DEFENSE NUCLEAR FACILITIES SAFETY BOARD

January 6, 2022

Staff Report

Pantex Plant Pit Inventory Review

Figure 2. (a) AL-R8 Sealed Insert cross-section
(b) AL-R8 container with packing material and sealed insert.

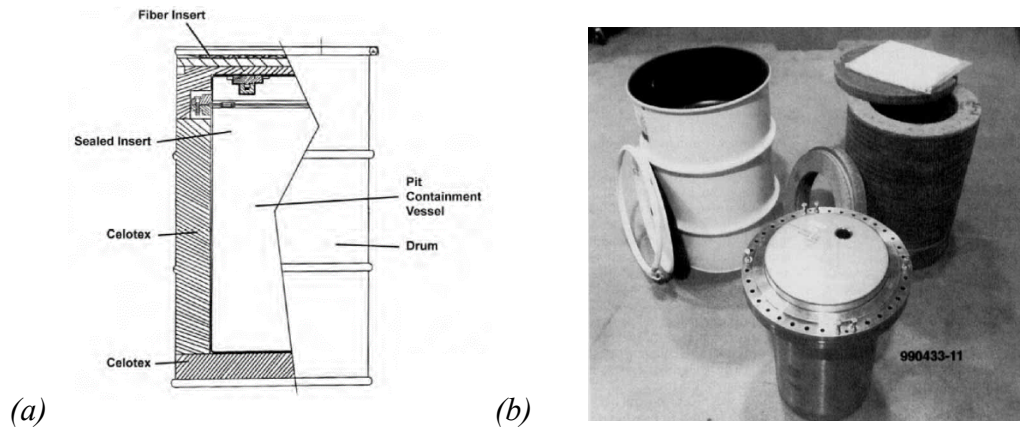
As discussed earlier, the AL-R8 container without a sealed insert does not provide a benign environment for long-term pit staging, notably in facilities without climate control, such as in Zone 4. AL-R8 drums are not leak tight and do not provide a sealed barrier that would confine radioactive material released by a breached pit. The Celotex™ packing material can create conditions that promote pit corrosion. Celotex™ is a fiberboard material made from sugar cane, paper, starch, and wax and can contain significant moisture and chlorides. In addition, a sealed insert provides additional thermal and radiological protection which can be important for certain pits. The sealed insert can provide enhanced criticality safety, protect the material handler from radiological dose, and isolates the stored pit from the products of thermal and radiological decomposition of the Celotex™ packing material. Board Recommendation 1999-1 noted:
